DESIGN REVIEW AND EXCELLENCE PANEL PROGRESS REPORT Area 5

13-19 Canberra Avenue
St Leonards South NSW 2065

FURTHER RESPONSE TO DESIGN REVIEW PANEL

The following clarifications respond to the final comments received from the Council and Design Review Panel in September 2021.

- **4.3.2 CONNECTION TO GREEN SPINE**

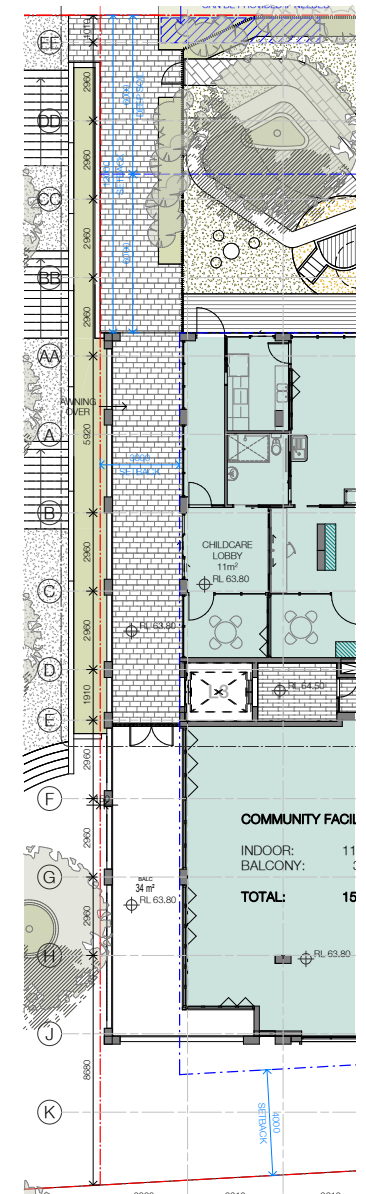
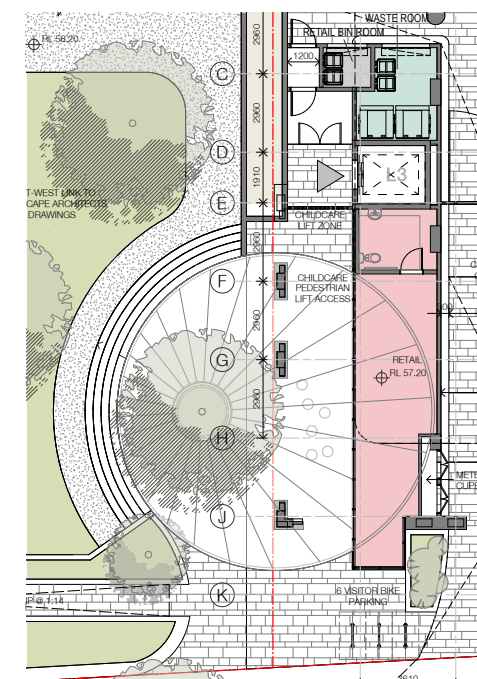
- A separated dedicated doorway to be considered. L1 access to the communal open space is currently only through the lift car

1. There is a significant level change between the building level to the residential lift lobby and apartments through to the community facilities, i.e community hall, childcare, green spine. A ramp/separated accessible doorway would be inefficient and hard to navigate in this tight space. The lift access provides the most direct and easy means to navigate the level change.

4.3.3 COMMUNITY OPEN SPACE & AMENITY

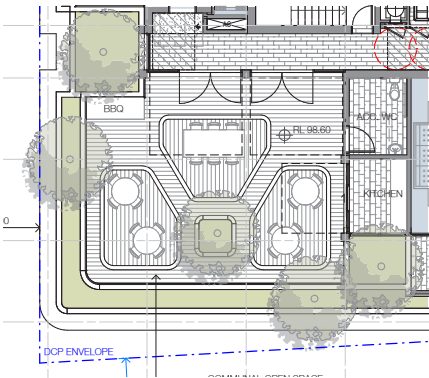
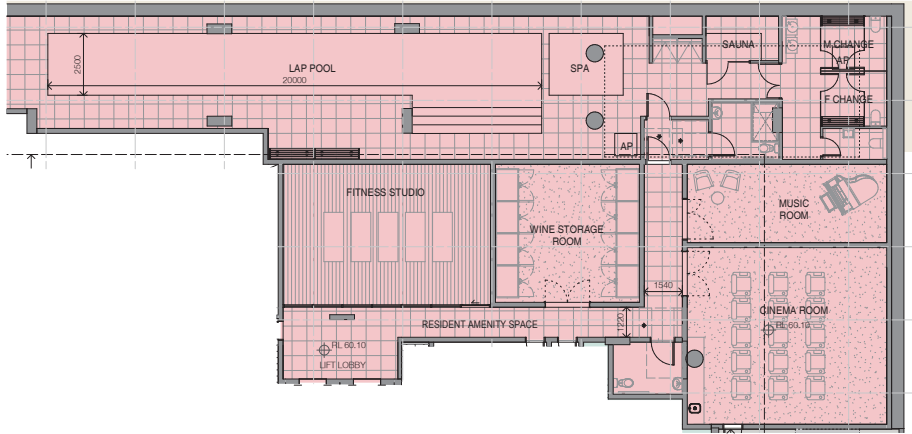
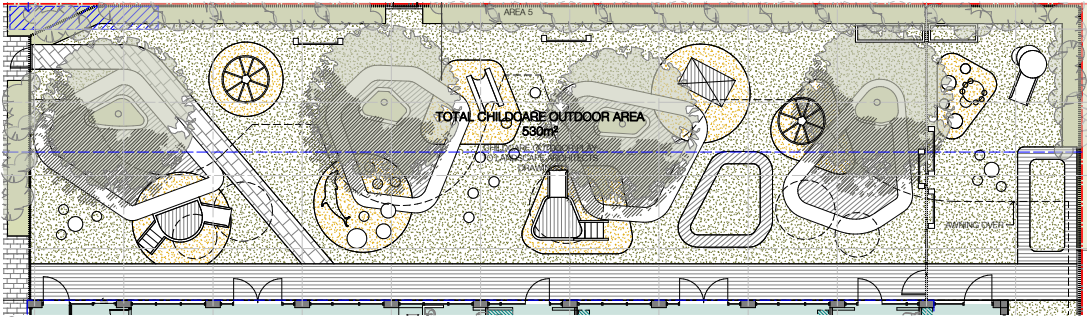
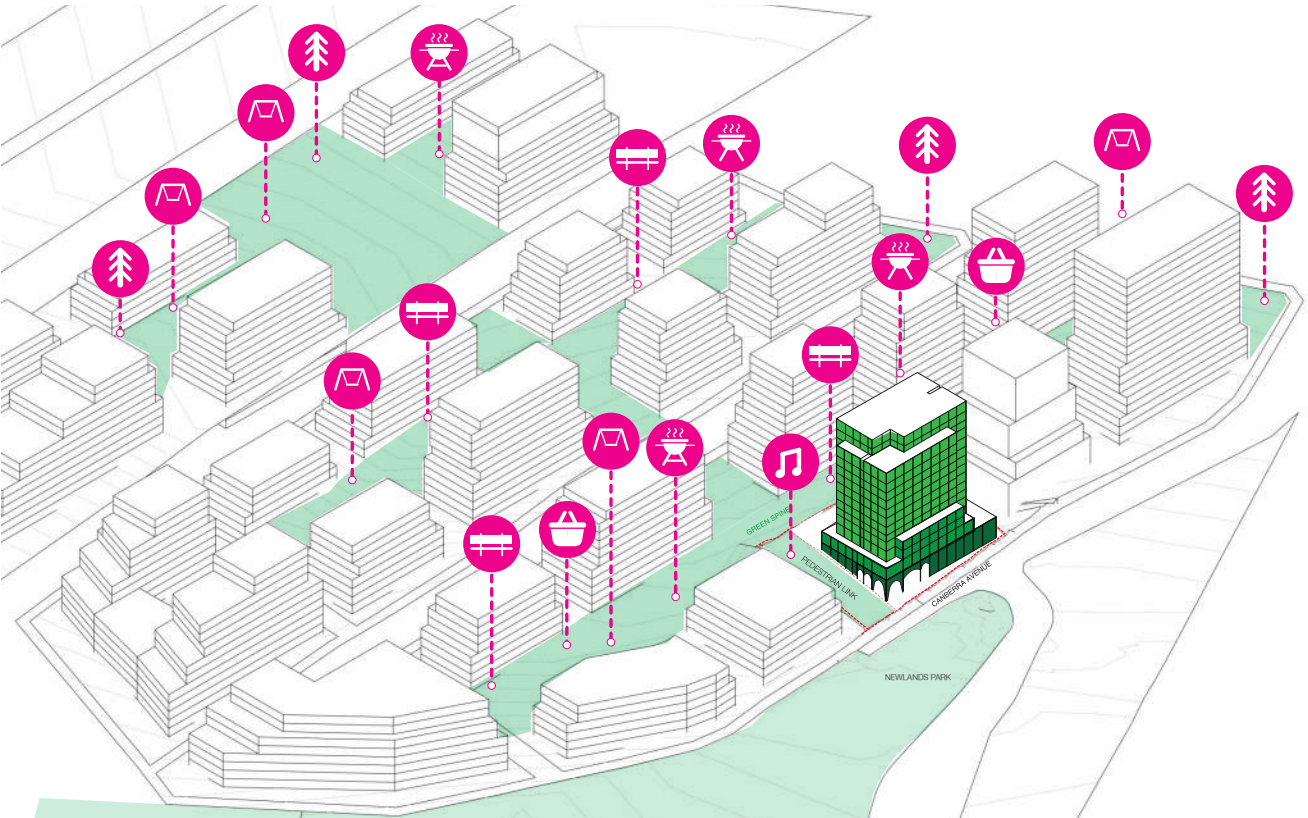
- Applicant needs to demonstrate the adequacy of communal open space.

1. There are 4 distinct opportunities for resident to engage and enjoy community and communal open space. These include; vast communal open spaces at the precinct level; After hour/weekend use of the expansive childcare outdoor play area; The programmed Upper Ground indoor community facility; and the rooftop communal open space with uninterrupted city views.

2. PRECINCT LEVEL - The site being situated in the heart of the St Leonards South Precinct, has direct access to a number of shared community amenities. Including council operated childcare, indoor community hall, BBQ areas, landscaped areas, child play zones, small parks, bench and picnic spaces. The site offers two key community spaces to the precinct and its residents being the Childcare and community hall which totalling 1050sqm of indoor and outdoor space as well as large civic pedestrian link through the precinct. Residents of the building have direct access to the greenspine and pedestrian link via level one connection.

3. PRECINCT LEVEL - OUTDOOR PLAY - Advised by the council's property section, the child care outdoor space could be used by the precinct residents outside of the childcare hours. This will provide around 530 sqm of engaging outdoor play zone for both the residents and the public.

4. INDOOR UPPER GROUND - The upper ground floor provides functional and exclusive resident facilities including private wine storage room, music room, fitness studio and cinema. The amenity level has been enlarge to further include a swimming pool, spa and sauna room to provide additional amenities to the residence.

5. ROOFTOP - The rooftop community space provides kitchen, BBQ and accessible toilet. Plus shaded outdoor seating areas which can accommodate multiple groups at a time.

- 4.3.4 Child Care Provisions**

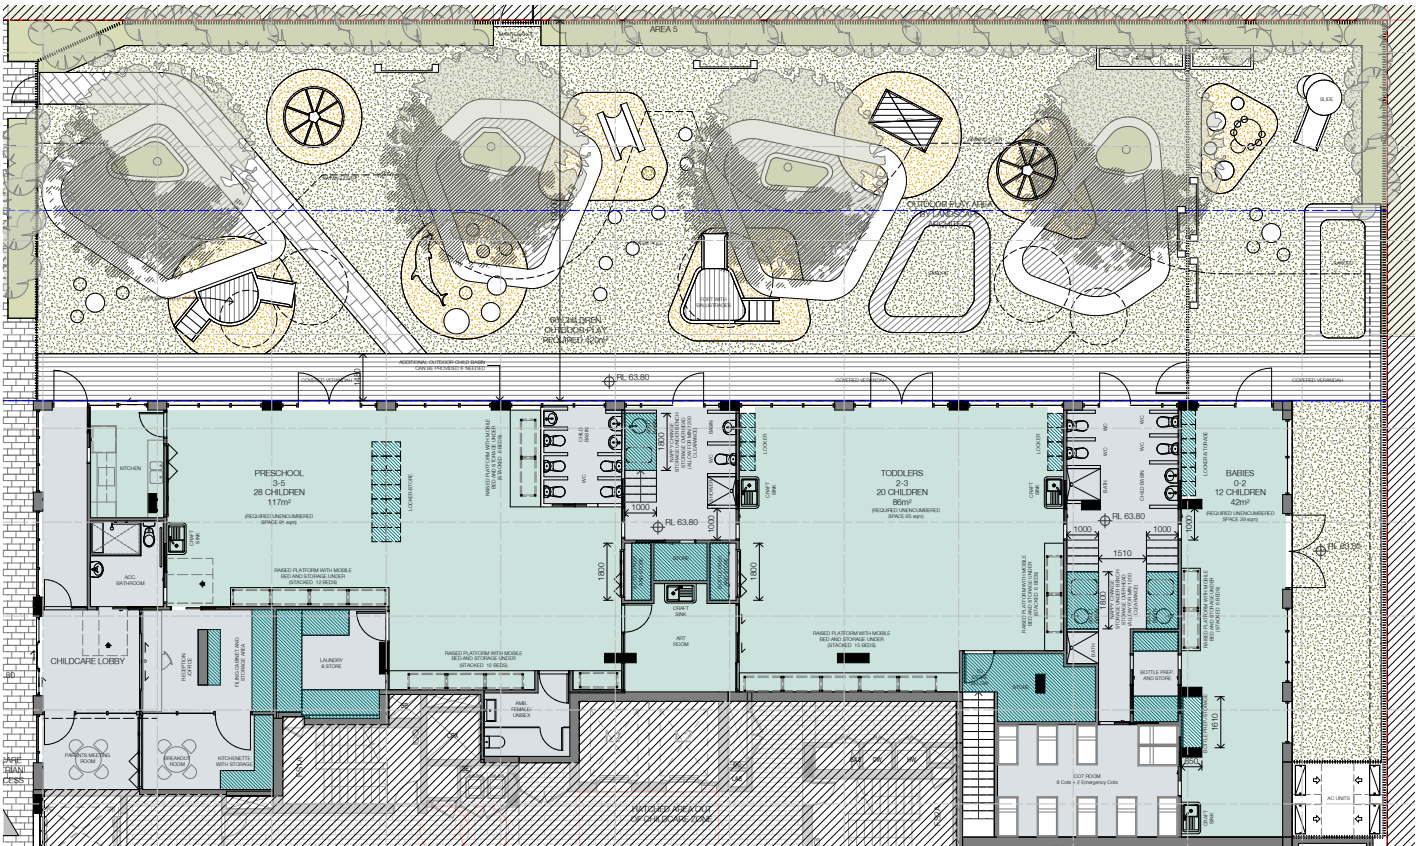
- Applicant to provide sufficient space to the childcare and work with council's childcare team to provide desired layout.

1. The applicant has been through multiple workshops with the council's childcare team and agreed on a brief to achieve the desired layout to satisfy council's childcare strategy.
2. The proposed layout provides additional area that exceeds council's requirement. Including 721.5sqm indoor area (req. 450) and 530 outdoor area. (req. 450)
3. The proposed amenities exceeds both the NCC standard and council's childcare guideline.
4. The spacious outdoor plan has been design by the landscape architects to provide both quiet and active play.
5. The outcome will be beneficial to both the childcare user and community residents.

• **4.3.5 TERRACE HOUSES**

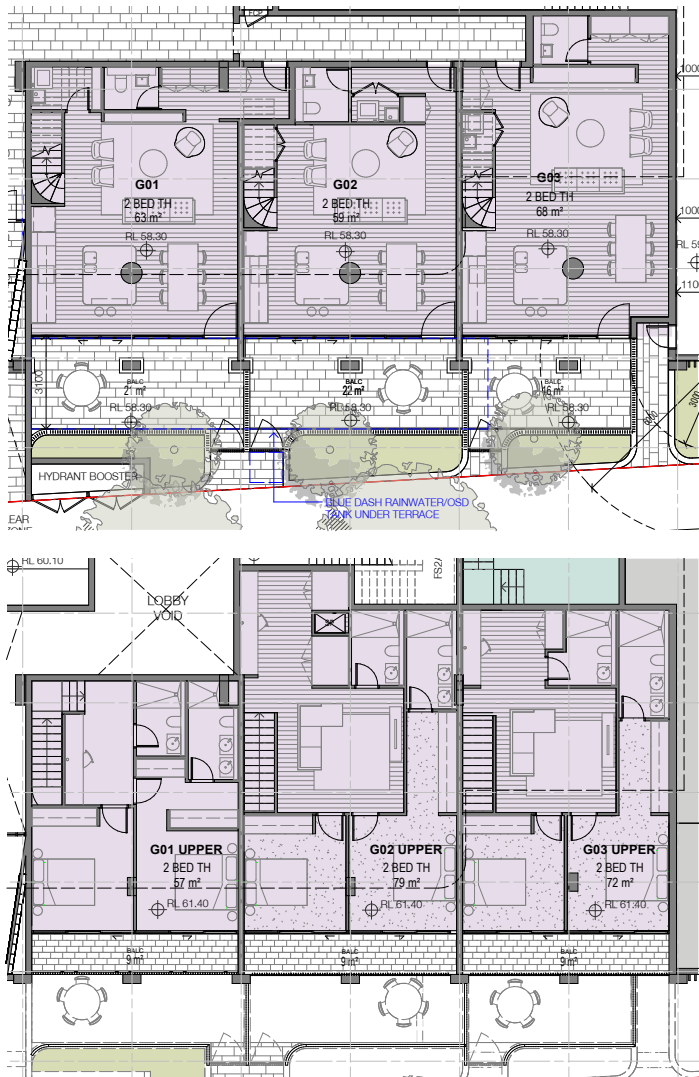
- The applicant is to justify the upper level layouts.

1. The apartment depth are not excessive. For example, for the terrace houses, the distance between the window to the back of the kitchen is around 6 m, which is far less than the ADG guide of 8 m. The overall depth vary from 8 to 10 m with the frontage of the terrace house been much wider (7m) than the ADG prescribed width.
2. The planning of the upper levels of the terraces and study nooks on typical floors allow for flexible-use spaces. With more people working from home more frequently we believe these spaces are a useful addition for leisure or work purposes.

• WEST ELEVATION

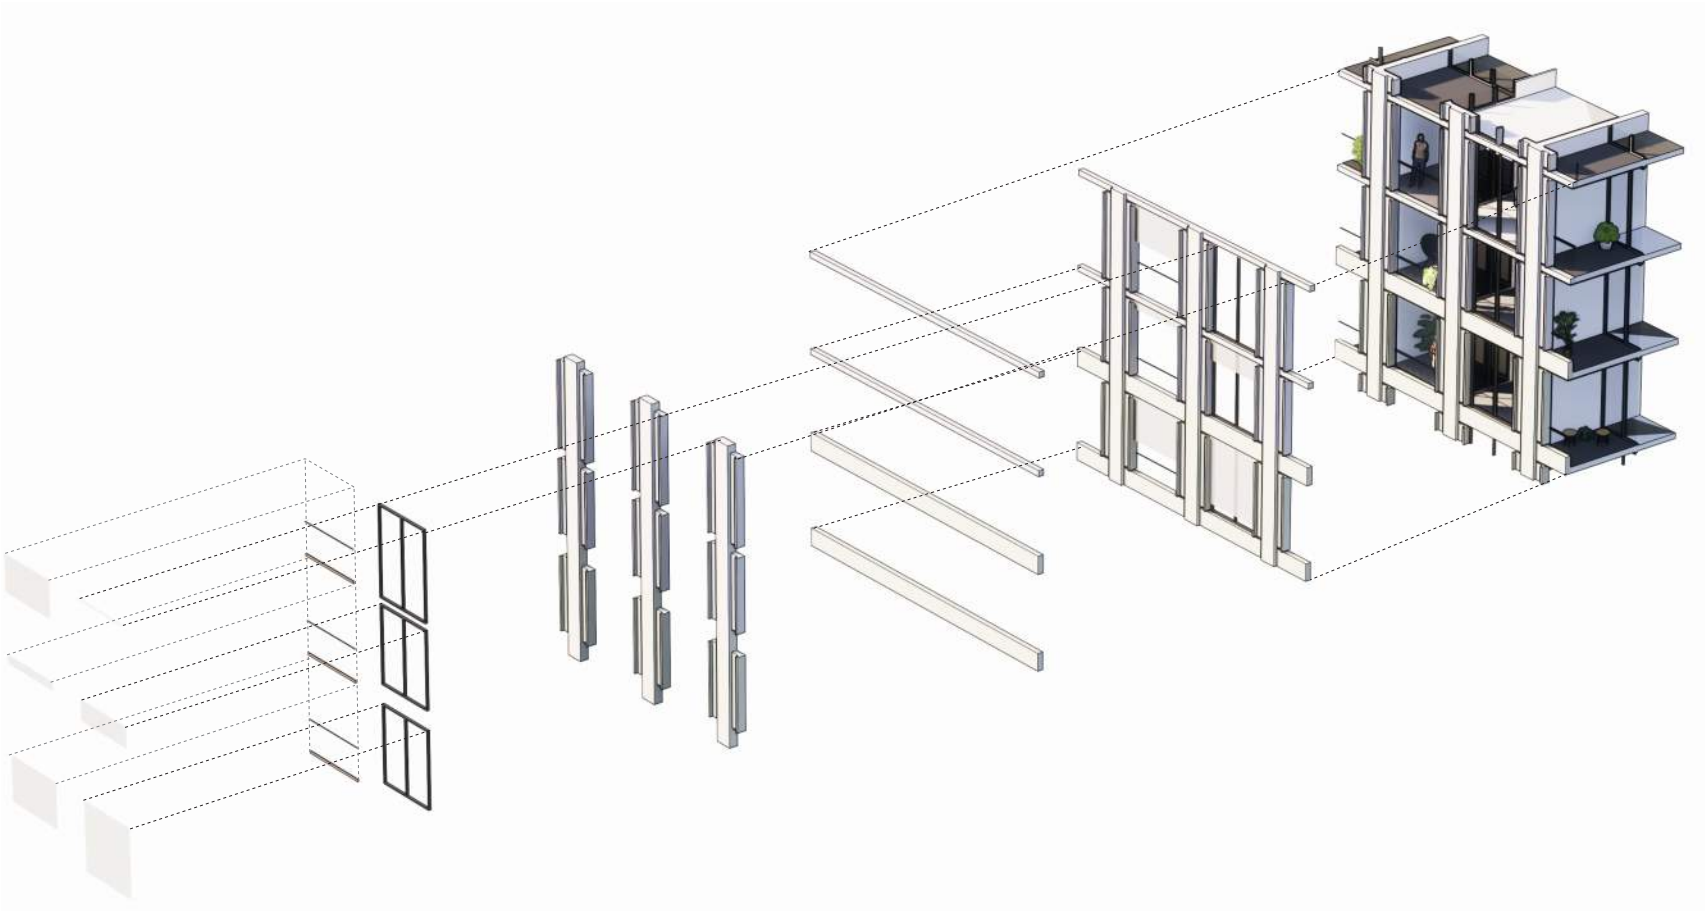
- The panel is concerned with the maintenance and longevity of the external roller blinds.

1. The proposed awnings provide sun-shading and privacy protection. Design for external use with minimum maintenance the awnings are mounted onto vertical guide rails. The operator has the option to tilt the bottom panel at various angles to suit the amount of shading required. There is also opportunity for colour to be added to the blinds to provide added delight for those looking in or at the facade.

SOLAR & CROSS VENTILATION

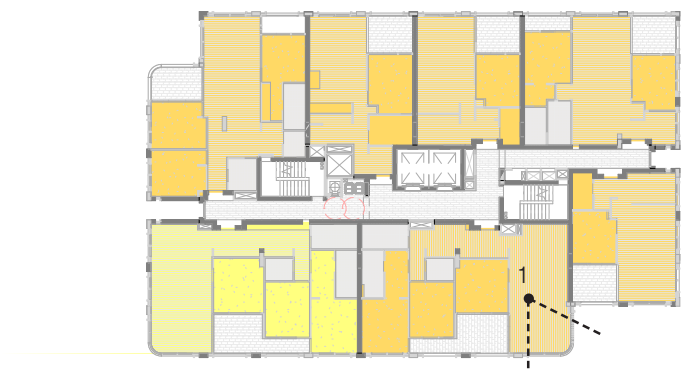
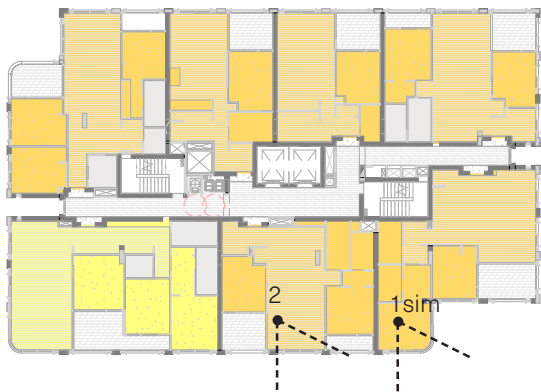
- The applicant is to demonstrate 2 hour solar access been provided to the east facing apartments.

- 1. Solar analysis has been performed for the entirety of the building.
- 2. Due to the orientation of the building, additional studies have been performed to analyse the sun penetration to the required number of east facing apartments. Only the East South corner apartments have been nominated as 2 hr solar apartments, they have been studied as per below, and achieves a 2hr solar penetration between the hours of 9-3 on the 21st of June.
